454 Conversion

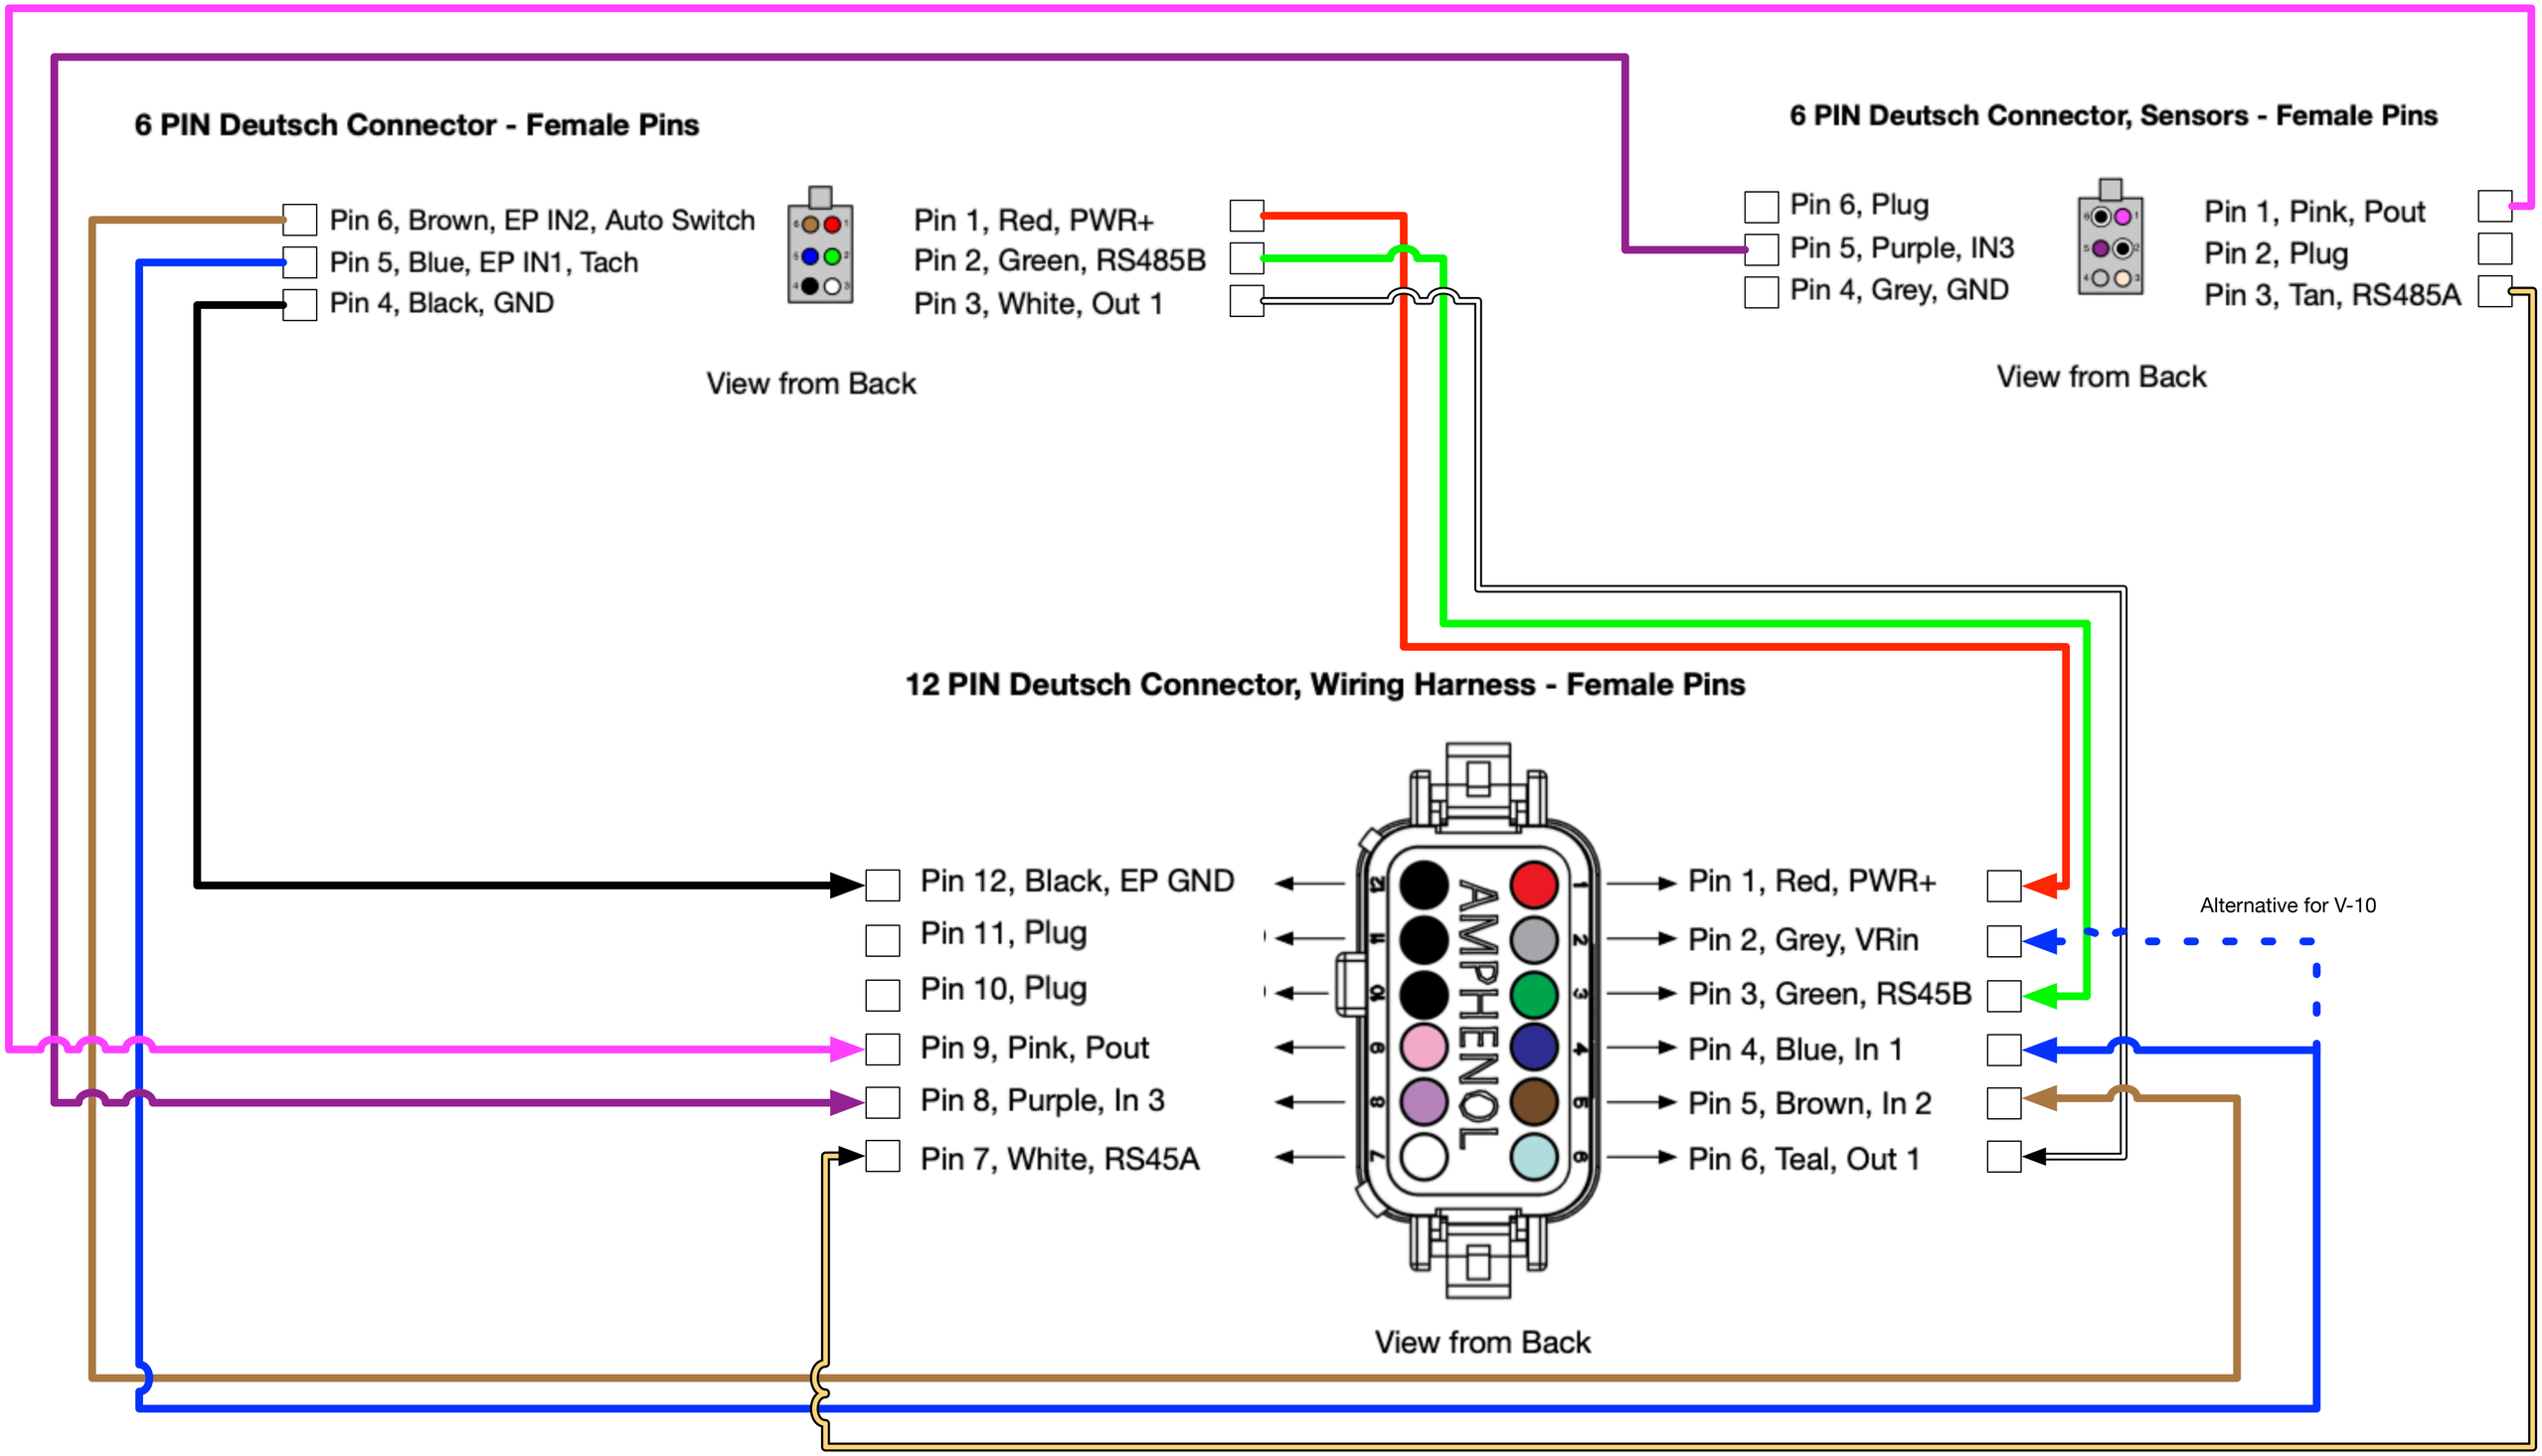
For a V-10, the blue wire for Tach will need to
be moved to Pin 2 VRin instead of Pin 4 IN 1
See dotted blue line
